CV MITRA HASANAH TEKNIK		
Report Title : Assessment of Instrument Device 2022		continued
End User Name PT INDO BARAT RAYON	Location <i>CIKAMPEK</i>	Recommendation: - To procure suitable transmitter for replacement . - To change material code in SAP with suitable transmitter for future use. - To perform calibration and rerange existing transmitter. - The existing transmitter specification is; STR93D-21B-1C0BDABA-507K-MB-CM-CC-TG-F1-TP.E1D9 - Recommended transmitter for replacement is; STR12D-21B-1B0BDABA-507K-MB-CC-TG-F1-TP-E1D9 - The similar issue for LT 4084
Tag no. LT4003	Description <i>Level Transmitter for H-401</i>	
Manufacturer <i>HONEYWELL</i>	Device <i>Level Transmitter DP Cell Type</i>	
Reference <i>Data sheet, Manual</i>	ACCEPTED / NOT ACCEPTED	
Method Method of assessment is mentioned here below; - Visit site for inspection equipment. - Check and verify equipment specification - Review equipment performance through operation report

Report Title : Assessment of Instrument Device 2022

End User Name PT INDO BARAT RAYON	Location <i>CIKAMPEK</i>
Tag no. <i>LT5003</i>	Description <i>Transmitter for vessel T-750</i>
Manufacturer <i>HONEYWELL</i>	Device <i>Level Transmitter DP

End User Name PT INDO BHARAT RAYON - CS2 PLANT	Location <i>CIKAMPEK</i>
Tag no. QT2036	Description <i>O2 IN FLUE GAS A-200</i>
Manufacturer <i>YOKOGAWA</i>	Device type <i>ZIRCONIUM OXIDE, INS ITU</i>
Reference/Model no <i>ZR402G</i>	ACCEPTED / NOT ACCEPTED

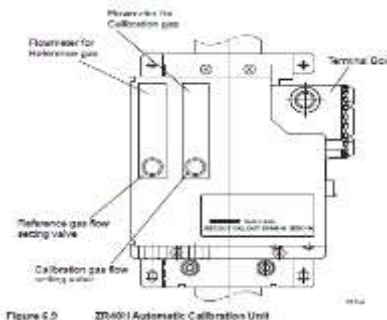
A Gas Cylinders

- No Calibration gas cylinder valid to used.
- Analyzer not calibrate and set up correctly
- analyzer supplied with model ZR40H Automatic Calibration Unit auto-switching of the calibration gas.

- Procure Calibration Gas Cylinders (Span Gas Cylinder)
- Set up analyzer calibration arrangement in order to able to calibrate in semi automatic calibration.
- Set up the reference gas and calibration gas flow rate as per manufaturer recomendation
- Calibrated the analyzer as per manufacturer recomendation
- Create item code/number for particular spares and analyzer
